**AUTHORIZATION TO DISCHARGE UNDER THE
NATIONAL POLLUTANT DISCHARGE ELIMINATION SYSTEM**

The Town of Newmarket, New Hampshire

**Young Lane
Newmarket, New Hampshire 03857**

FACT SHEET

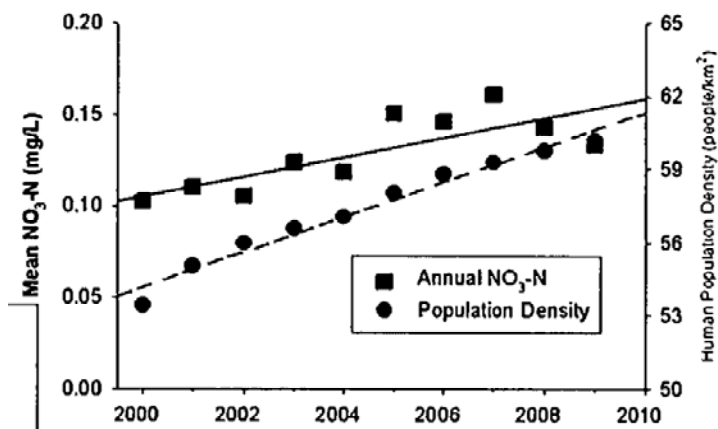
To support our comment that non-point sources pollution can be the major source of impairments to the Great Bay, we offer three general information graphs taken from publically available information.

The first graph is the populations density in the Lamprey River Watershed and nitrate-nitrogen concentrations in the Lamprey river near Packers Falls from the May 10, 2011 SWA Science Symposium. This graph demonstrates the linear relationship between population increases and increases in nitrogen levels in the Lamprey River.

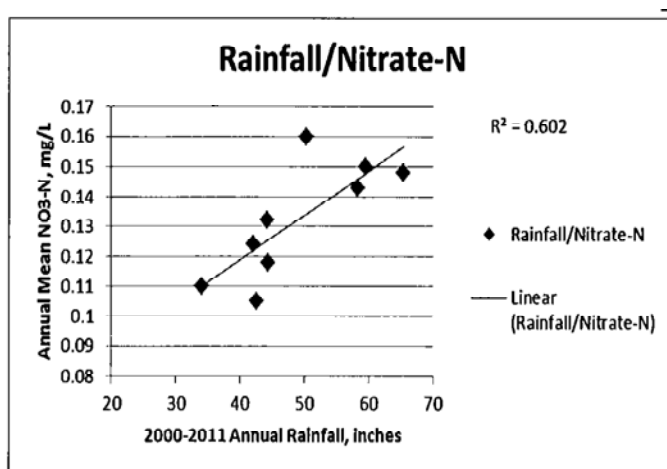
The second graph plots the rainfall in Durham, NH versus the nitrate-nitrogen levels in the Lamprey River near Packers Falls. This graph demonstrates the linear relationship between nitrogen levels and rainfall.

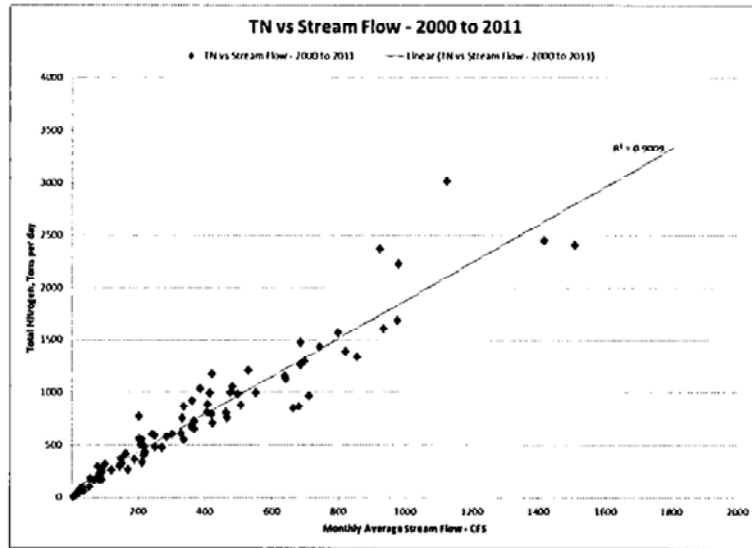
The third graph is information taken from the UNH sampling station LMP-73 for total nitrogen (particulate and total dissolved nitrogen) plotted as the monthly mean total nitrogen in tons per day versus river flow.

This location is at Packers Falls in Newmarket, upstream of the head of tide dam on Route 108 approximately 2 to 3 miles, in the fresh water section of the Lamprey River. This graph demonstrates that the total nitrogen in the river is directly related to the river flow and runoff rather than the point sources discharges.

Figure 27: Relationship between Minimum Dissolved Oxygen and Chlorophyll-a at Trend Stations

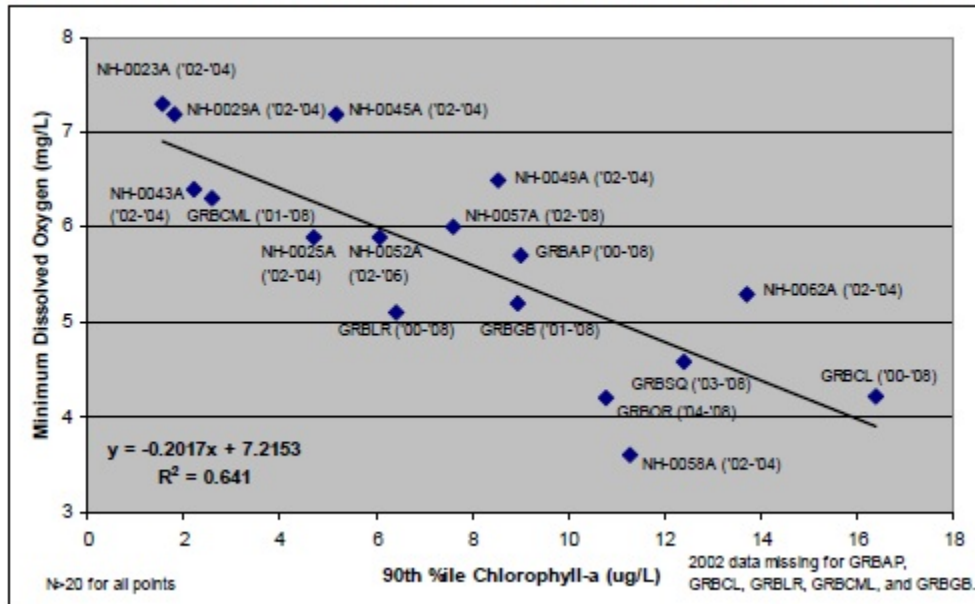
EPA also disagrees with the assertion that “[n]one of the river-specific data indicated a significant relationship between minimum DO and algal growth.” Long-term trend monitoring from the tidal rivers, including the Lamprey River, are part of the statistical analysis performed by NHDES in connection with the proposed numeric thresholds showing a statistically significant relationship between minimum DO and 90th percentile chlorophyll-a. (NHDES, 2009, Figure 27 (reproduced below)). Data from NH-0025A, at the mouth of the Lamprey River, is fully consistent with the overall trend. NHDES did note that the GRBLR datasonde, located just below the tidal dam in the Lamprey, should be used with caution because “dissolved oxygen impairments were observed but were likely amplified by stratification and possibly sediment oxygen demand”; so that a 0.45 mg/l threshold for the estuary as a whole would be used, even though dissolved oxygen violations were encountered at GRBLR with a median TN concentration of 0.451 mg/l. The major implication of the GRBLR data is that the Lamprey River may be more sensitive to algal growth and nitrogen concentrations due to stratification effects; the Coalition has failed to suggest any interpretation that would indicate that a *higher* TN threshold would be sufficiently protective in such a stratified environment.

Figure NUT3-1: Long-term trends for chlorophyll-a concentrations measured monthly at Adams Point in Great Bay

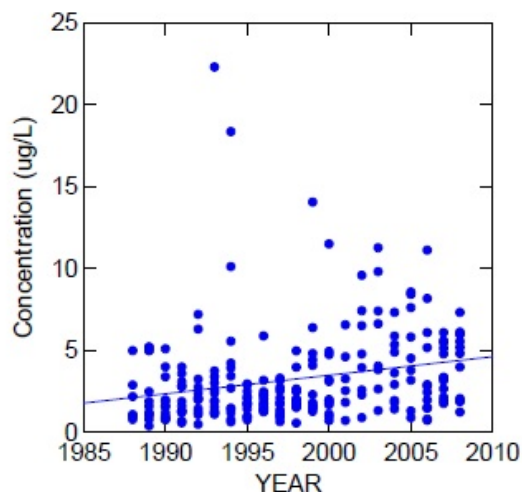
EPA disagrees with the Coalition's contention, based on selective use of data, that chlorophyll-a concentrations in Great Bay did not increase between 1993 and 2000. The average annual concentrations shown in Exhibit 8 masks the trend that is apparent when the full dataset is considered. The PREP 2009 Environmental Indicators Report Figure NUT3-1, reproduced below, shows a clear increasing trend between 1988 and 2008, with very obvious peaks in maximum chlorophyll-a in 1993 and 1994, just prior to the documented onset of eelgrass decline in 1996. (PREP, 2009b) The commenter's assertion that algal growth could not have been the cause of eelgrass decline is therefore incorrect.

EPA notes that the same figure the commenter cites as showing that algal levels increased by only 1 ug/l from 2001 to 2008 (a box and whisker plot) also shows that the 75th percentile concentrations increase by over 3 ug/l, or more than double, in the same period. Indeed, this is consistent with the commenter's own Exhibit 8, which shows annual averages ranging from approximately 2.4 to 6 ug/l in 2001 to 2008, compared to annual averages consistently below 2 ug/l prior to 2001. However, EPA notes that more recent data do not indicate a statistically significant increasing trend in chlorophyll-a through 2011 in Great Bay proper (PREP, 2012), in

Figure NUT1-5: Nitrogen loads to the Great Bay Estuary from different sources in 2009-2011

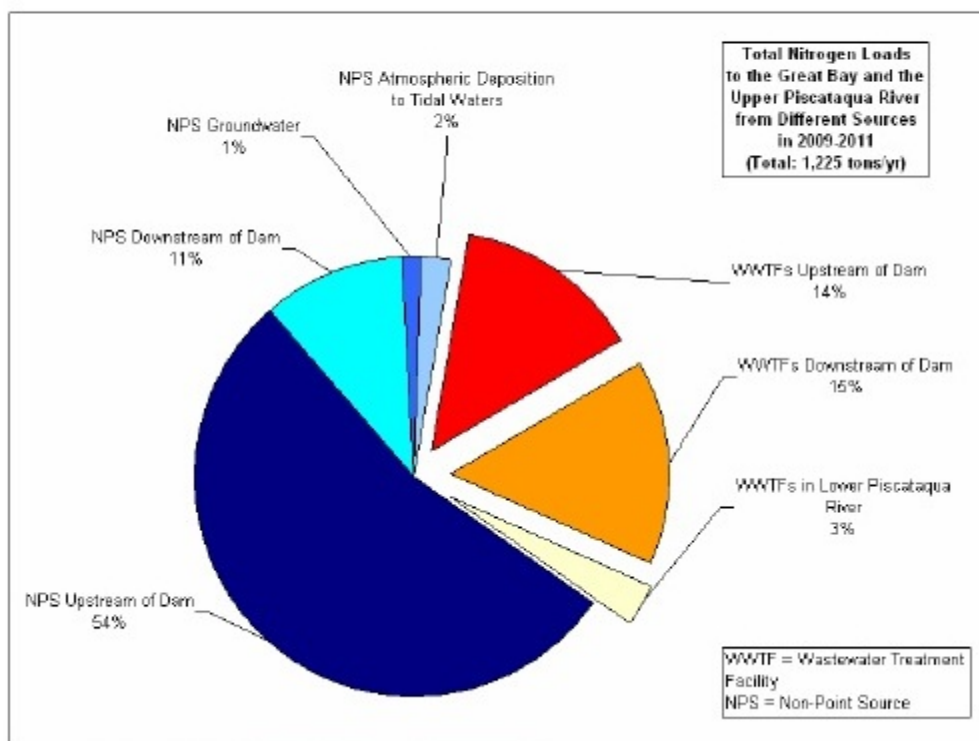
Exhibit 11 does not show municipal loads, only discharge flows from selected Great Bay POTWs during dry weather. There are little data available to indicate whether there has been an increase in nitrogen POTW loadings as these facilities were not reporting nitrogen concentrations or loads under their past permits. Rochester is a clear example of this where nitrogen discharge concentration levels have increased over time resulting in an increase in nitrogen discharge loadings independent of any flow increase. Quarterly monitoring provided by Rochester indicates that for 2001 – 2006 total nitrogen discharge levels ranged from 13 -18 mg/l and for 2007 – 2011 total nitrogen discharge levels ranged from 20 – 35 mg/l. Moreover, even if the recent increase in loads were primarily attributable to nonpoint sources, the fact is that total loadings exceed acceptable loadings and the point sources contribute significantly to these exceedances. Additionally, since permitted flows exceed actual flows, the potential for increased point source discharge loadings in the future is significant and needs to be addressed.

reported number is 31%. (PREP, 2009a at 12). EPA notes that the most recent calculations for 2009 to 2011 indicate that point sources account for 32% of the nitrogen load to the Great Bay and Upper Piscataqua River. (PREP, 2012, Figure NUT1-5 (reproduced below)).

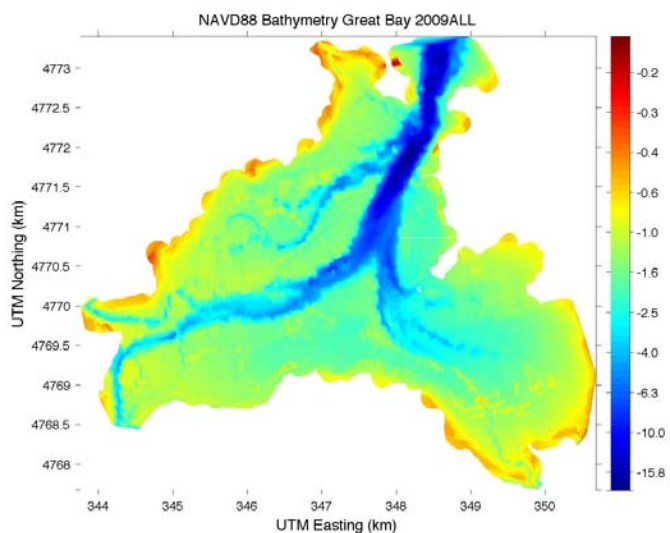
Finally, the DES analyses relied upon by EPA provide no demonstration that eelgrass losses in the Bay are, in fact, correlated to reduced transparency. If they were, eelgrass losses from the deeper Bay waters would be the most prevalent – they are not. (See Ex. 13, Figure 5, presentation of Fred Short, Impediments to Eelgrass Restoration.) Recently, Professor Fred Short has acknowledged that the large tidal fluctuation in Great Bay allows the eelgrass to receive sufficient light and that, therefore, transparency is not likely a controlling factor in this area. (See Exs. 21 and 22 – MOA Meeting minutes.) In contrast to the transparency theory of eelgrass loss, higher losses appear to have occurred in shallower environments where the most light is available, and eelgrass are healthiest in the deeper waters. (See Figure HAB2-2, 2009 PREP Report.) This could evidence that macroalgae or shoreline development are adversely impacting eelgrass populations. Therefore, mandating TN reduction because of an assumed connection between eelgrass loss and transparency was in error.

In conclusion, throughout the late 1990s as eelgrass declined, chlorophyll-a levels remained constant, even though data confirm that TIN levels increased by 40%. These data confirm that chlorophyll-a growth in the system is not significantly responding to increase inorganic nitrogen levels (the component of nitrogen that supports plant growth). Likewise, data from the tidal rivers do not show any significant relationship between algal levels and minimum DO occurrence. The assumption that nitrogen levels and excessive phytoplankton growth in the system is causing widespread impairment is simply not justified based on the available data. As noted earlier, the focus needs to be on macroalgae using an adaptive management approach.

Response #32: Secchi disc depth is a relative measure of water clarity. The secchi disc data cited by the Coalition was collected with limited quality control by volunteers sampling in one location (off a dock at Adams Point), which may not be representative of where eelgrass declines occurred in Great Bay proper. Due to questions of data reliability and representativeness, the secchi disc data was not used by NHDES in its analyses. EPA agrees with NHDES's decision to exclude this source of data from its analysis.
